## *City of El Paso – City Plan Commission Staff Report*

**Case No:** SUSU16-00023 Rocket Warehouse Park Unit 3 Replat A Subdivision  
**Application Type:** Resubdivision Preliminary  
**CPC Hearing Date:** June 2, 2016  
**Staff Planner:** Armida Martinez, (915) 212-1605, [martinezar@elpasotexas.gov](mailto:martinezar@elpasotexas.gov)  
**Location:** West of Dyer and South of Sean Haggerty  
**Acreage:** 14.56 acres  
**Rep District:** 4  
**Existing Use:** Vacant  
**Existing Zoning:** C-4 (Commercial)  
**Proposed Zoning:** C-4 (Commercial)  
**Nearest Park:** Jorge Montalvo Park (.80 miles)  
**Nearest School:** Desertaire Elementary (.56 miles)  
**Park Fees Required:** \$103,360.00  
**Impact Fee Area:** N/A  
**Property Owner:** Dyer Palms, LTD.  
**Applicant:** Dyer Palms, LTD.  
**Representative:** CEA Group

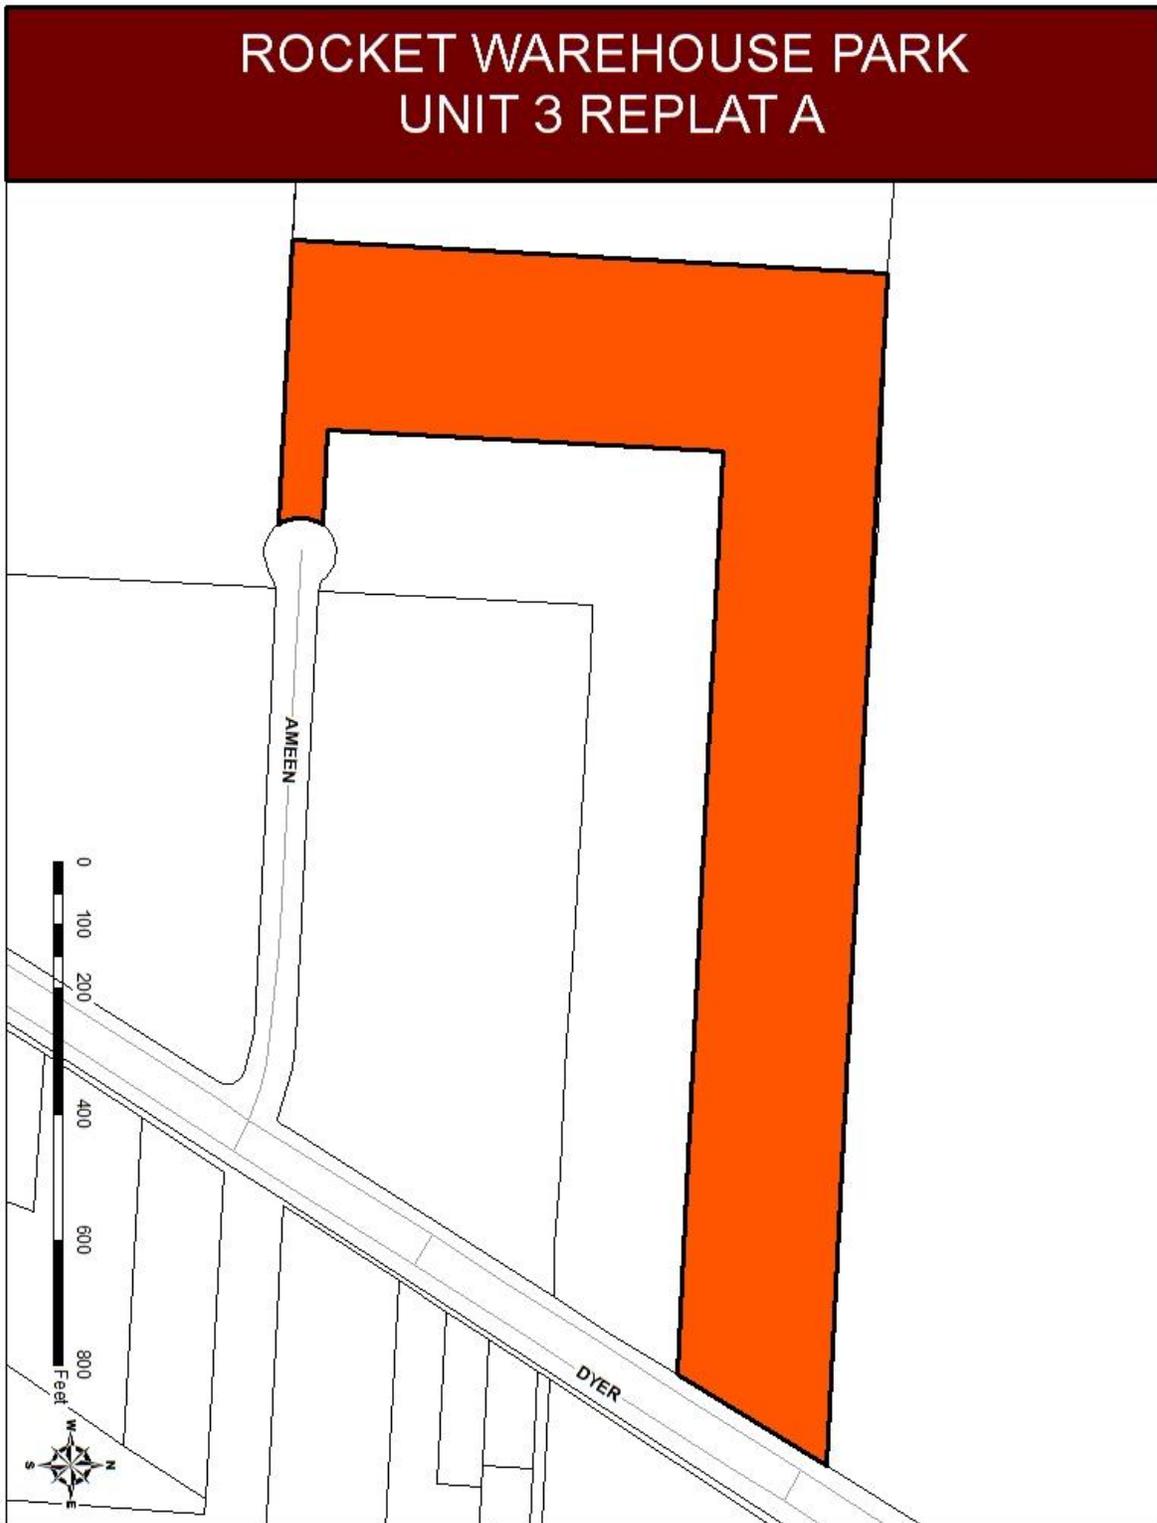
1. Coordinate with TXDOT for access and drainage requirements.
2. No stormwater will be allowed to discharge into Dyer St. or Ameen Dr.; they were not design to take in any outside flow.
3. Show proposed drainage flow patterns on the preliminary plat and identify the flow patterns proposed on Legend Table. If the proposed private pond shown will contain the developed run-off, it should be able to handle a 100-year storm.
4. Comply with FEMA flood zone requirements. The CLOMR application shall be submitted and approved by FEMA and submitted to the City prior to any grading or approval of the subdivision improvement plans. Add a reference note with application number.
5. At the improvement plan stage, any proposed ponding area shall have enough capacity to hold the developed runoff for a designed 100-yr storm event.

*The El Paso Water Utilities – Public Service Board (EPWU-PSB) easements shall be labeled “**Reserved PSB Easement**”. Anchor PSB Easements may be required to accommodate the proposed fire hydrants as well as the proposed water services.*

Lot number needs to be changed. “Lot 1” already exists, Block 1, Lot 2A may be used.
